3: City of Oakland Crosswalk Policy

4: Design Review

5: MacArthur Blvd (High Street to Enos)

Attachments: Crosswalk Policy matrix, MacArthur Blvd (High St to Enos) draft striping plan

City of Oakland Crosswalk Policy

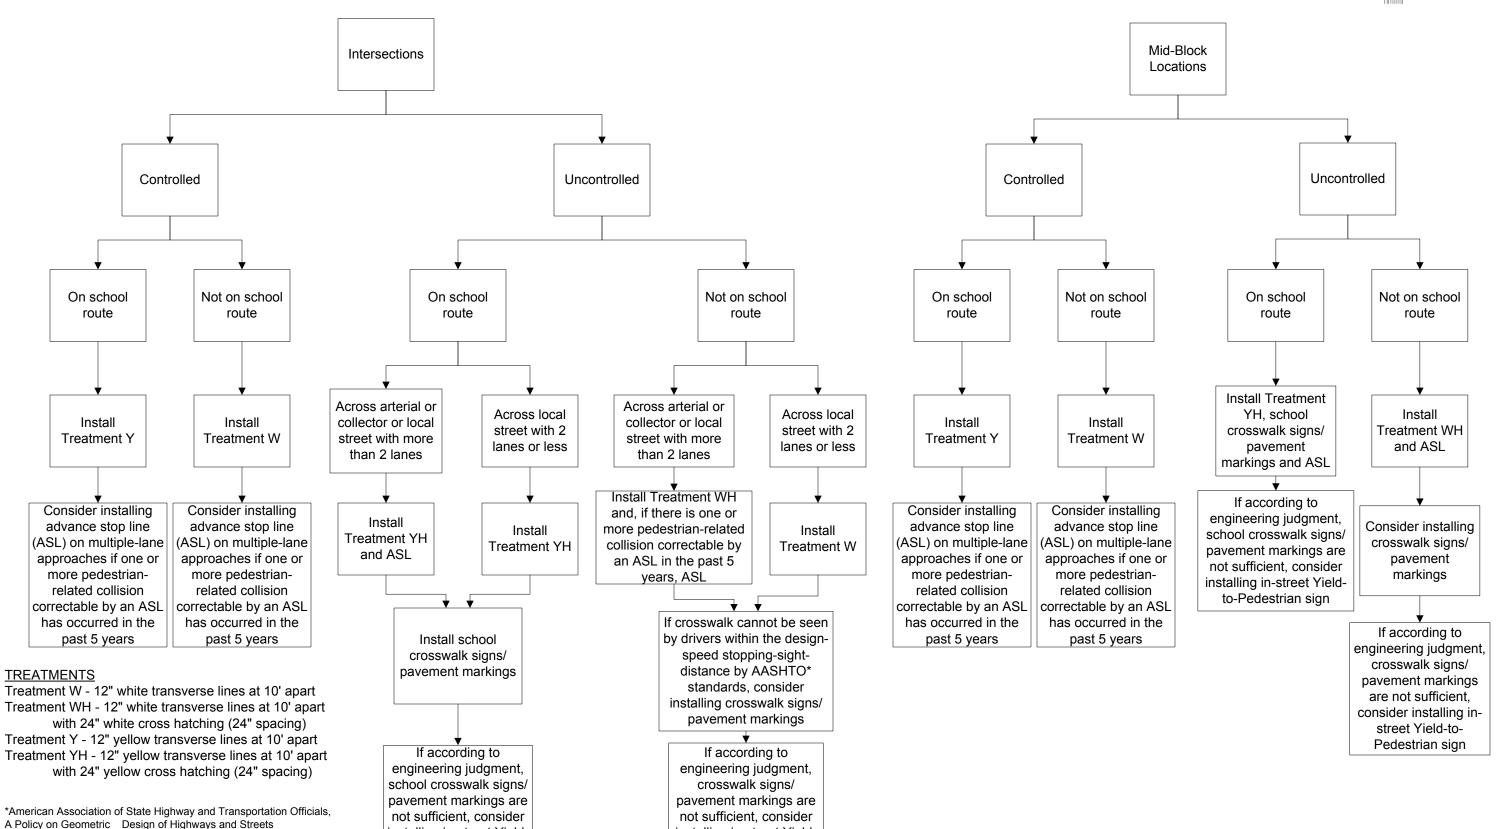
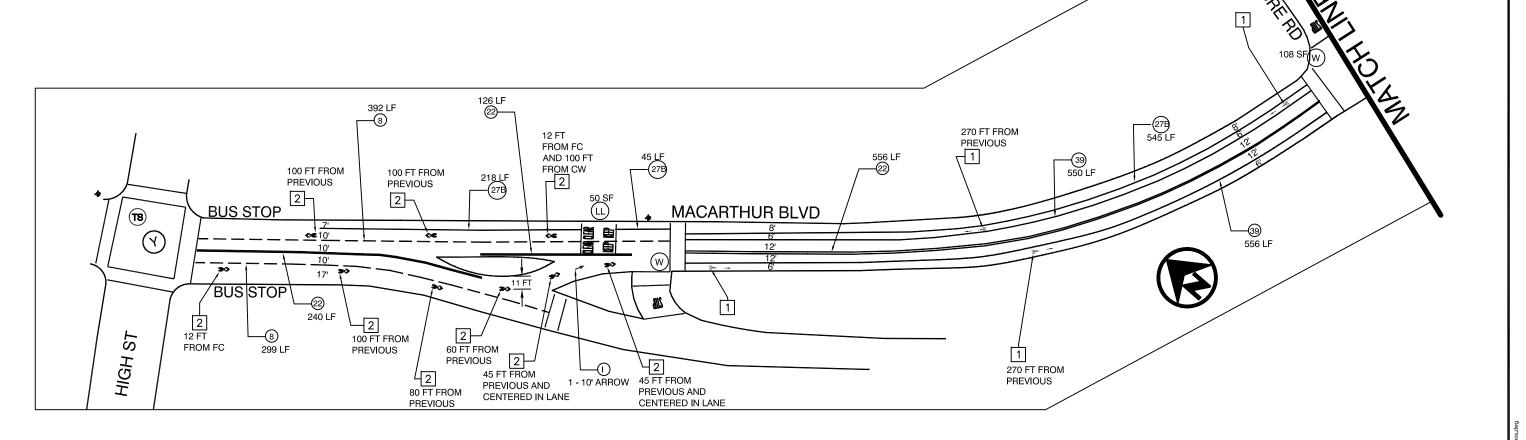
Rebecca – Even one transit stop can create enough demand to consider a higher visibility crosswalk, such as Telegraph at 61st Street.

Ruth – Consider using observed rather than posted speeds. Also, the flow chart doesn't accommodate intersections near freeway on/off ramps, or intersections near places with exceptionally high speeds.

Jonathan – Did you consider writing guidelines for changes to signal timing? Joe – This is something we adjust reactively. We don't have the resources to seek poorly timed intersections to change to meet the new 3.5 feet/second requirement

Kassie – Will crossing times be adjusted to meet this new requirement? Joe – As the intersections are brought to our attention, yes.

Ron – Pedestrians should be clearly prioritized over other road users. Stop removing crosswalks.

Ann – What is the issue here? Why can't all crosswalks be marked and visible?

Joe – The FHWA 2002 recommendations section sends the decision-maker into a set of options for less common cases, such as those. This policy covers a majority of intersections, which is better than what we had before.

Joe – Limited resources and evidence that marking all crosswalks diminishes their effectiveness.

SIGNING & STRIPING CARTHUR BLVD FROM GREENACRE RD TO HIGH ST

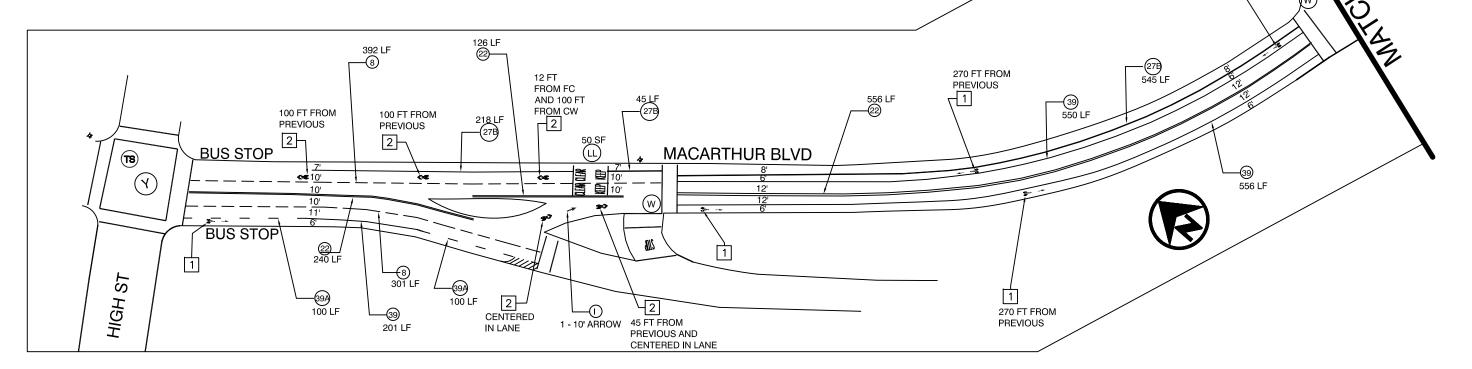
As part of an existing multi-street resurfacing contract that includes this segment, the plan is to install a bikeway, per the recommendations of the LAMMPS study. This will require council approval since the plan will remove a lane and a significant amount of (underused) parking. Discussion focused on the eastbound merge after High St where high-speed traffic presents a design challenge. <u>Discussion</u>:

Jug handle for bikes? Not enough money for a new light.

Dedicate the left lane for through-movement?

AC Transit is concerned about the removal of travel lanes and the possible effect on operating speeds.

Vote: encourage bicyclists to take the left lane or queue and wait for cars to pass. No one likes either option.
